PZ&B Staff Combination Memorandum: Landmarks Preservation Commission and Town Council

SUBJECT: COA-24-0018 (ZON-24-0043) 100, 101, 102, and 103 FOUR ARTS
PLZ—SOCIETY OF THE FOUR ARTS

MEETING: January 22, 2025, TC
February 12, 2025, LPC

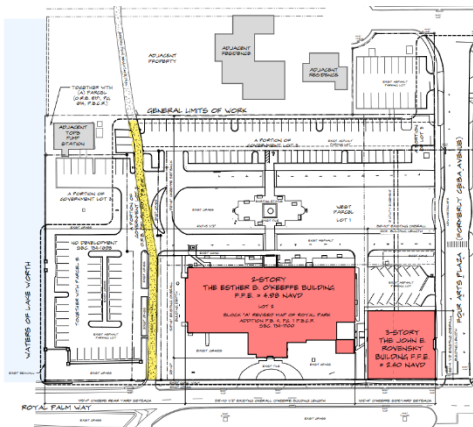
The variance request currently seeks to reduce the parking to 234 spaces, representing a reduction of 81 spaces (26%). A parking study by Kimley Horn was submitted that presents parking demand for visitors and employees. The study concludes that *“Accounting for variations in time-of-day demand for uses on site, the peak parking needs for the campus are anticipated to be approximately 232 spaces during the weekday peak period in which the theater is in use. Therefore, the parking needs for the site are anticipated to be met.”*

The Town’s code does not offer alternate parking requirements based on parking demand calculations.

Proposed Trail

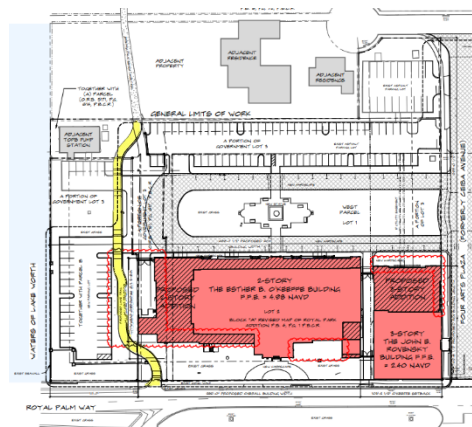
As previously mentioned, the existing Lake Trail right-of-way traverses the west campus towards the western side of the site. To accommodate the proposed additions to the O’Keeffe building, the application seeks to abandon this easement to reconfigure the pedestrian path slightly to the west. The formal abandonment and new dedication will be processed separately, however, is it recommended that it be discussed during the site plan review since it impacts the proposed configuration of the site (and possibly additional parking space loss). A general consensus for the direction of the application as it pertains to the relocation of the Lake Trail would be appropriate.

South Elevation – Summary of Revisions:

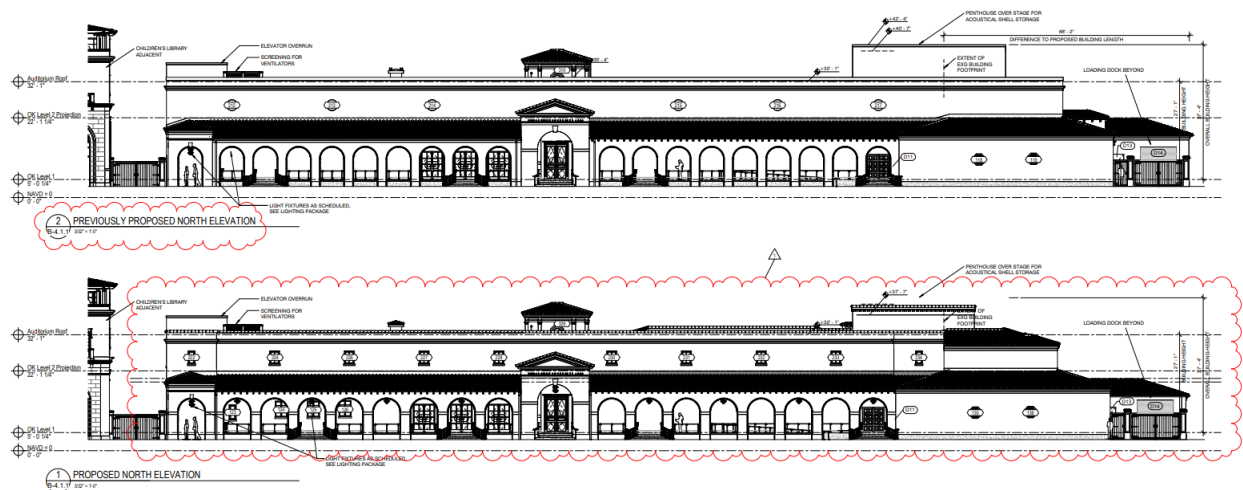
At the November 12, 2024, LPC meeting, the project was deferred to the January 22, 2025, meeting to re-study the north arcade’s articulation, examine elements deemed too tall, such as the fly tower and the west addition’s roofline, and to eliminate the southeast corner addition.

- Window trim color lightened to off-white pending paint analysis, with verdigris accent color for doors and specialty windows.
- Southeast addition (1,026 GSF) now removed from proposal, Mizner’s southeast windows in this location to be rebuilt according to original drawings.

- Revised to cascade the eave lines of the one-story roofs of the southwest additions down progressively moving westward.
- Second-story parapet replaced with tile roof; chimney, four windows, and an 11-bay open-air loggia integrated. Three windows are now also provided on the second-floor southeast corner (matching the original location in elevation).

- The 11-bay open-air loggia is integrated into the south façade design, centered over octagonal windows, using the reference of Mizner’s open-air loggias for the Embassy Club for the piers and brackets. The roof over this zone has its own massing, elevated with offset eaves and a hipped roof to read separately from the western expansion. Ornamental (nonfunctioning doors) were added to the back wall of the loggia.

- The 1st-floor plane break offset doubled to 2 feet (from 1 foot).
- The extent of westward expansion was reduced by 3 feet.
- Acoustical Penthouse: Height is reduced by 2 feet, and width is reduced by 7 feet.

- Acoustical Penthouse: Crenelated corbeling and barrel tile cap detail added to provide traditional scale and color.
- Groupings of windows to the west are tied together with common sills and centered over octagonal windows below.

- The additions do not touch Mizner’s tower.

North and East Elevations – Summary of Revisions:

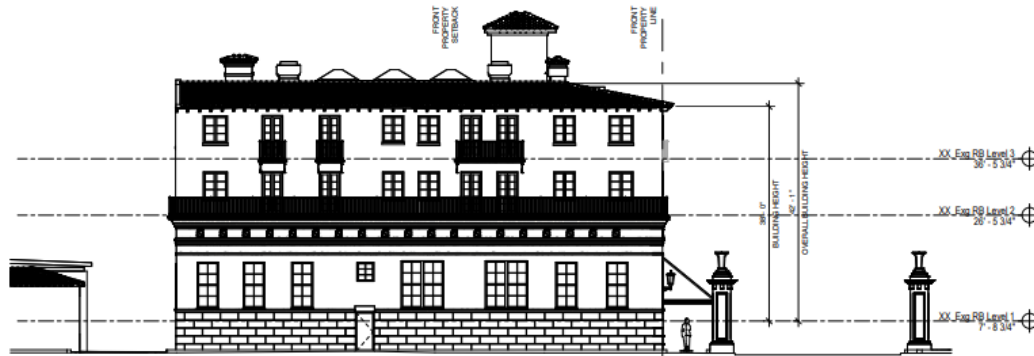
At the November 12, 2024, LPC meeting, the project was deferred to the January 22, 2025, meeting to re-study the scale of the windows and doors to ensure they are subordinate to or match the existing structure, reduce the prominence of the entrance, connection, and pavilion elements, review precedents within the Town, and scale down the third-floor boardroom.

- All openings and details have been revised/reduced in scale to reduce overall reading.
- Hyphen has been made much quieter visually, the first-floor cornice made simpler and lower. Arched windows removed from east elevation.

- The northeast pavilion windows are now smaller, more similar to King Library windows.
- The second-floor typical windows match the existing building, increased in number (for spacing more consistent with the existing building).

- The second-floor north wall moved south by 3 feet.
- The northwest tower windows were changed to grouped arched.
- The water table is now removed, arched openings removed on the east elevation and reduced on the north.

- The north arches match the height of those on the King Library.
- The entry arch is significantly smaller.
- A small door for children has been added next to the main entry/egress door.

- Ornamental grillwork will cover the entire storefront.
- The amount of stone reduced in favor of stucco; the tall water table and quoining now removed.

- The proposed board room pavilion roof ridge was lowered by 3 feet and is now to be under height of existing roof. Pavilion eaves were lowered by 18" to match the existing building.

- The pavilion metal roof and storefront below were changed from dull bronze color copper to verdigris pre-patinated copper.
- Pavilion massing broken into multiple elements, massing revised, all details revised. The entire board room massing shifted south by 5 feet and the ridge is now centered on building east elevation. Eaves converted from integrated gutter and broad standing seam fascia to

- finer soffits (12" overhang) plus half-round copper gutter.
- Small windows were removed.
- Corner window was removed.
